R.E. Ginna Nuclear Power Plant, LLC

Subject: Response to Request for Additional Information (RAI) dated November 9, 2004,
Regarding the Proposed Control Room Emergency Air Treatment System
(CREATS) Modification
R.E. Ginna Nuclear Power Plant
Docket No. 50-244

REQUEST FOR ADDITIONAL INFORMATION

CONTROL ROOM EMERGENCY AIR TREATMENT SYSTEM

R-45 Block Diagram

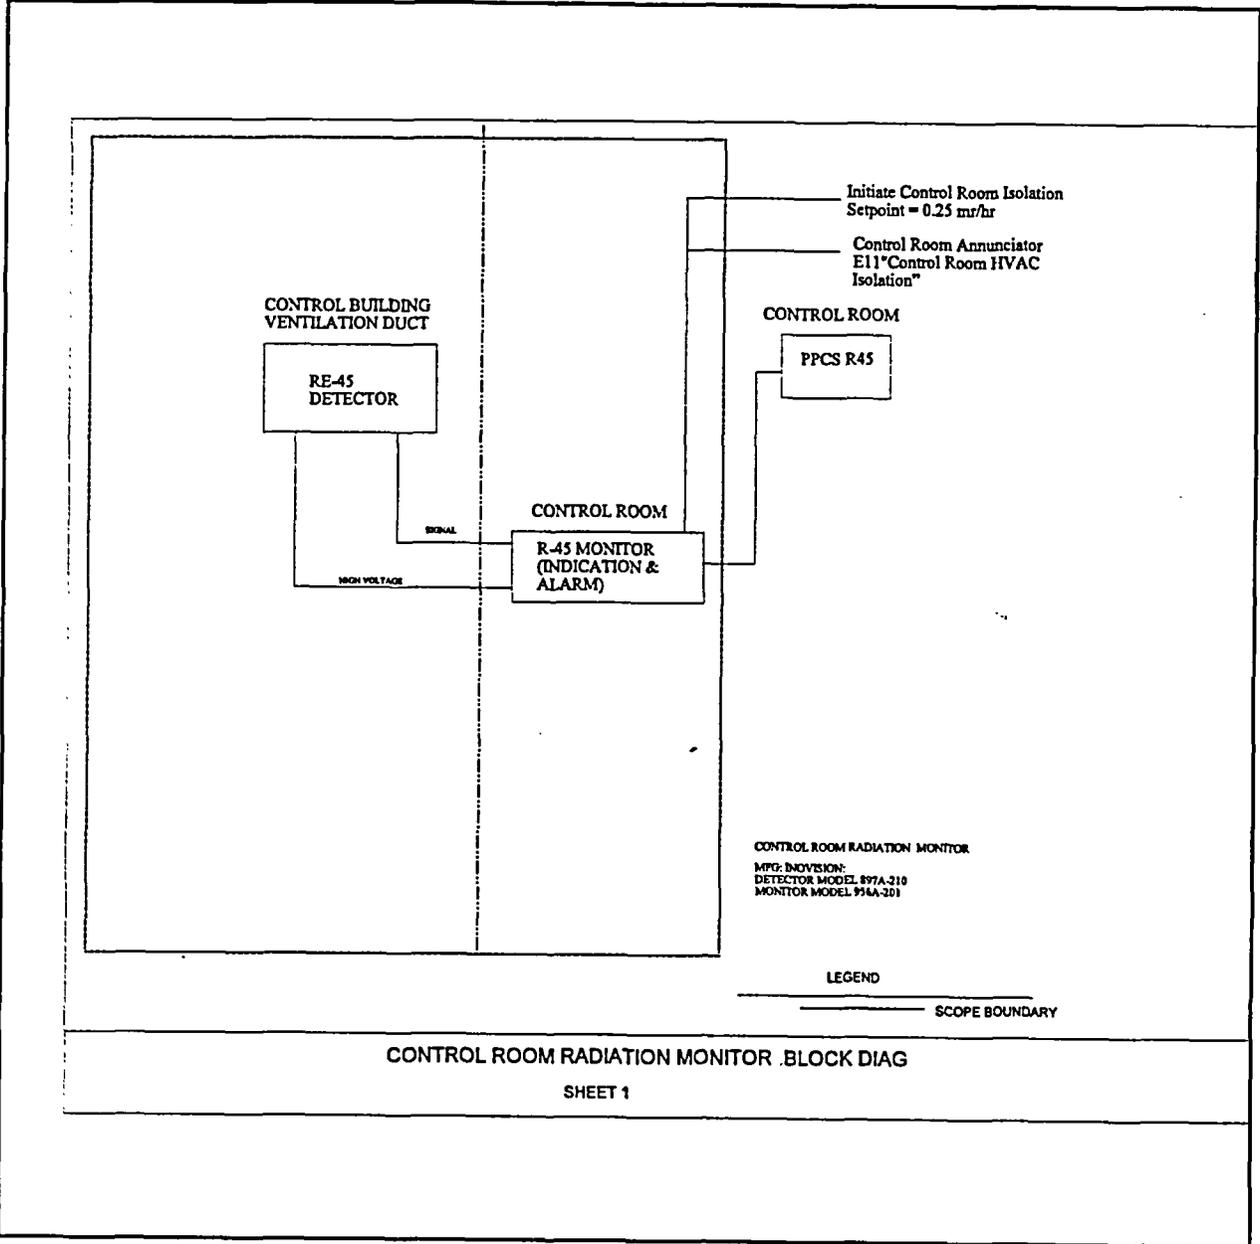
In accordance with your letter dated September 10, 2004, you stated in Attachment 1, Design Analysis DA-EE-2001-013, that the limiting analytical limit (AL) for the control room radiation monitor is 0.91 mr/hr. The previous AL for these instruments was 0.96 mr/hr. Since the new AL is less conservative than the previous value, Design Analysis DA-EE-2000-009 for the control room radiation monitor setpoints should be revised to indicate the correct Limiting Safety System Setting (LSSS). Technical Specifications Table 3.3.6-1, "CREATS Actuation Instrumentation," should also be revised to reflect the new LSSS and the performance based operability requirements for the Channel Operational Test.

Design Analysis DA-EE-2000-09 has been revised to reflect the new AL and appropriate sections included as Attachment 5. The proposed updated revision to Technical Specification Table 3.3.6-1 is included as Attachment 6.
